Natgasoline LLC, Beaumont, Texas, Project
Technical Information to support GHG PSD permit

**RE: Updated Cost Calculations for Carbon Capture and Sequestration (CCS)
Greenhouse Gas Prevention of Significant Deterioration Permit
Natgasoline LLC Gas-to-Gasoline Project, Beaumont, Texas**

**Natgasoline LLC Response to 20 December 2013 EPA Determination Letter
Beaumont Gas to Gasoline Plant Project
Updated Process Description and Process Flow Diagrams**

FIGURE 2-2

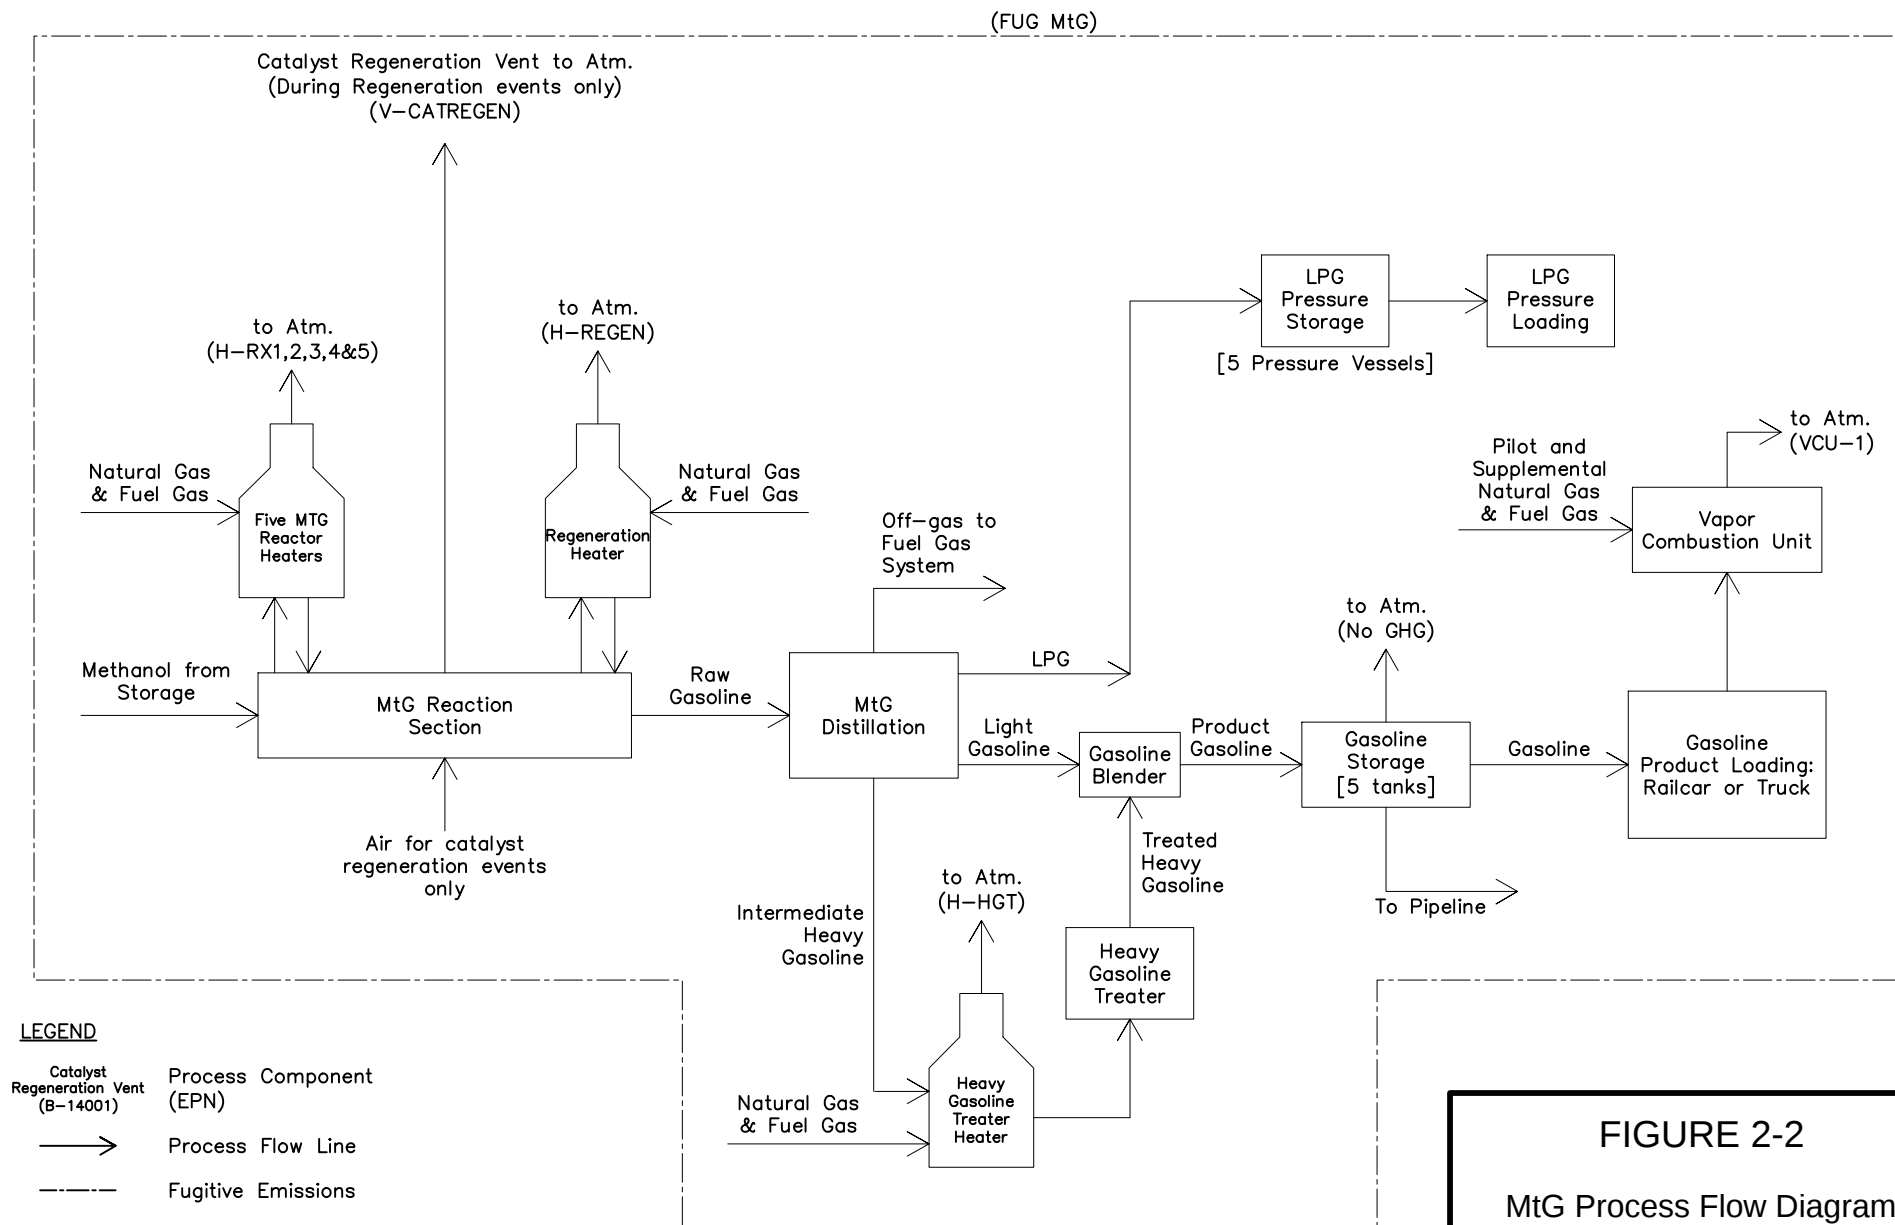
Blake: I did not change the fuel requirements to the regenerator. However after reading the response to EPA's questions dated January 10, 2014, it appears that there is NO Fuel combusted at this unit- Please let me know if the air to this unit has spontaneous combustion. I think that there is some conflicts in the SOB I sent you that needs to be clarified. It would be useful to clarify it in the project description for the catalyst regeneration.

Bonnie,
OK, I'll make sure that the related discussion in the SOB is correct.

The MtG catalyst regeneration is more of a process than a unit. The catalyst is regenerated in-situ (i.e., without removing the catalyst from the reactor vessels). The MtG regeneration heater is a gas-fired combustion source that provides indirect heat to heat up the circulating regeneration gas stream during the catalyst regeneration process. There is no "combustion" per se within the catalyst bed. The catalyst bed is heated by the circulating gas stream (which contains oxygen) under flameless conditions to oxidize carbonaceous catalyst deposits and convert those deposits to CO and CO2.
